<b><u>AGENDA PACKET</u></b>		
<b><u>SEPTEMBER 11, 2018 MEETING</u></b>		
	<b><u>CAL#</u></b>	<b><u>PAGE</u></b>
<b><u>AGENDA</u></b>		<b>3</b>
<b><u>COMPOSTING TOILET AT ONATRU FARM, 99 ELMWOOD ROAD, SOUTH SALEM</u></b>	<b>Cal #07-18PB</b>	
Planning Board application, dated August 4, 2018		<b>4</b>
<b><u>REQUESTS FOR RELAXATION ON SEPTIC REQUIREMENTS PER PLANNING BOARD RESOLUTIONS AND WETLAND PERMITS</u></b>	<b>Various Cal #s</b>	
No new materials		<b>-</b>
<b><u>HIDDEN POINT FARMS, 153 SILVER SPRINGS ROAD, SOUTH SALEM</u></b>	<b>Cal #56-18WP, #09-18SW</b>	
Kellard Sessions Review Memo, dated September 6, 2018		<b>8</b>
Wetland and Stormwater Permit applications, dated August 13, 2018		<b>13</b>
Cover letter, Recreational Design and Construction, dated August 9, 2018		<b>20</b>
Development plans and details, D'Andrea Surveying & Engineering, dated August 8, 2018		<b>22</b>
Cover letter, Soil and Wetland Sciences, dated August 9, 2018		<b>28</b>

**AGENDA**

RE: Wetland Permit and Stormwater Permit  
Hidden Point Farm, LLC  
153 Silver Spring Road  
Sheet 48, Block 10057, Lot 46

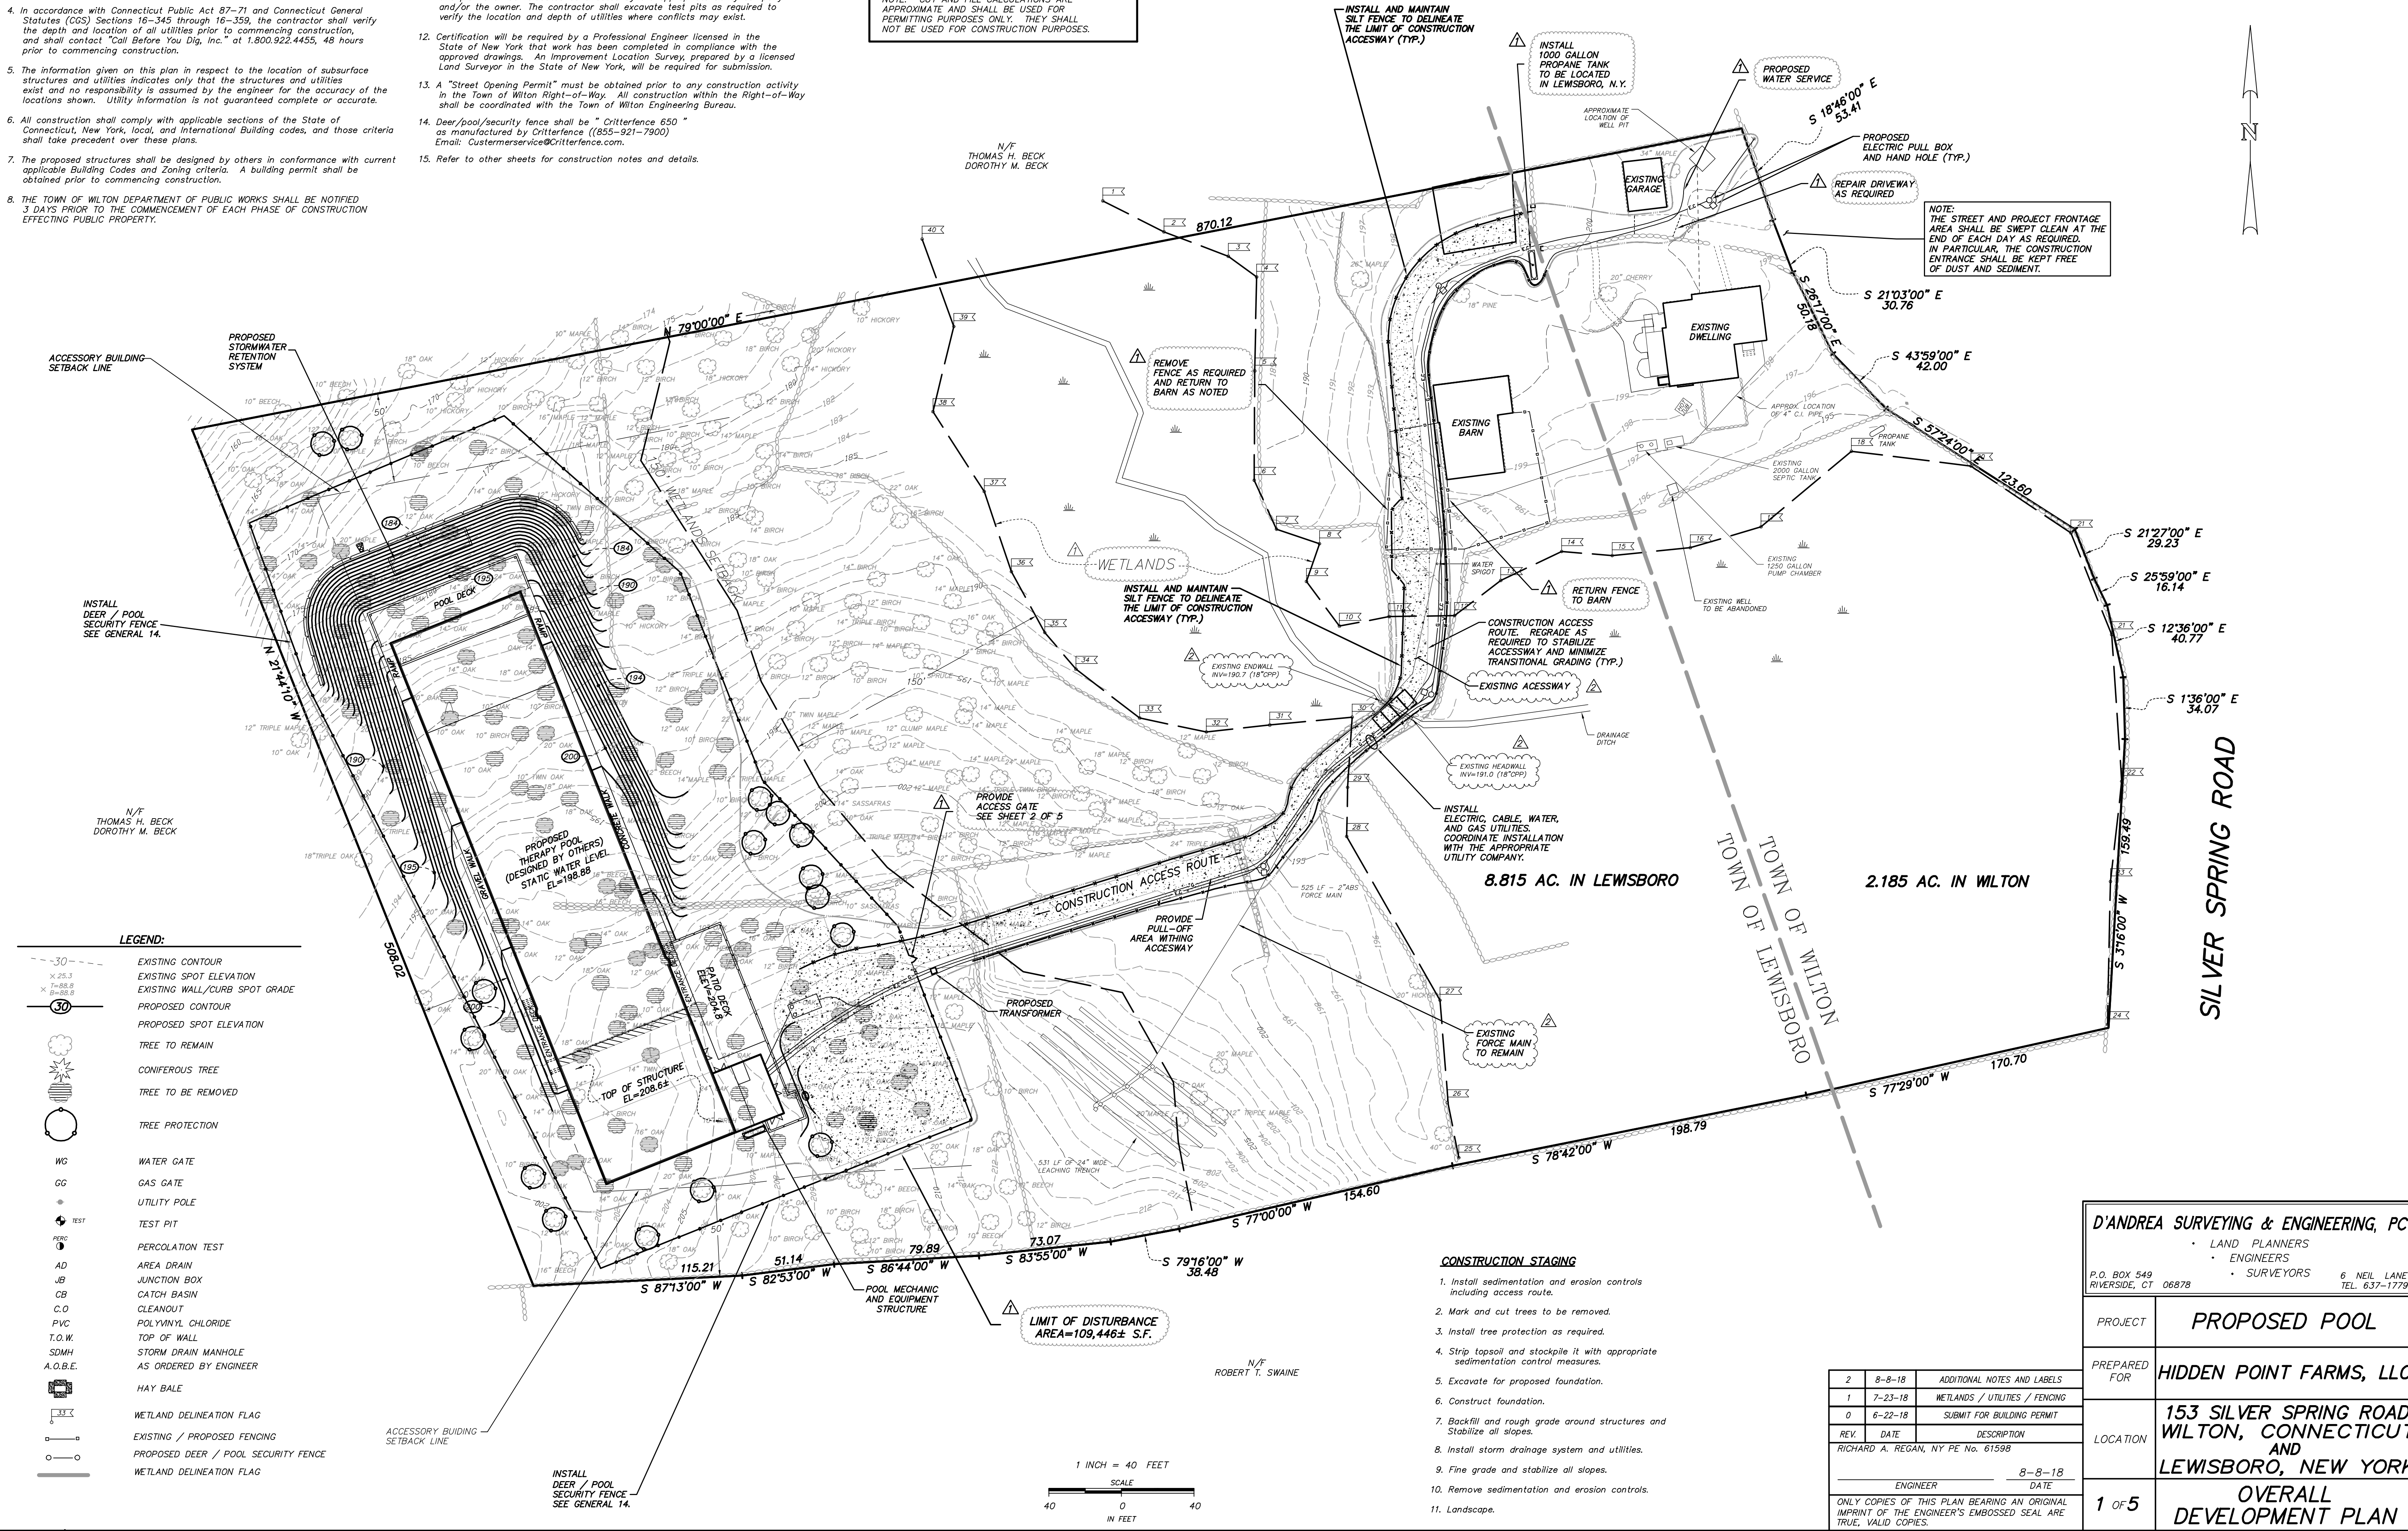
21. Note #9 on Sheet 1 refers to a potential future well; any proposed well shall be shown on the site plan and approved by the Planning Board and WCHD.

22. Notes #10 and #11 on Sheet 1 refer to the final location of proposed utilities; these notes shall clarify that any change in location (from that shown on the site plan) must be previously approved by the Town of Lewisboro Building Inspector, Town Engineer and Town Wetland Inspector, as applicable.
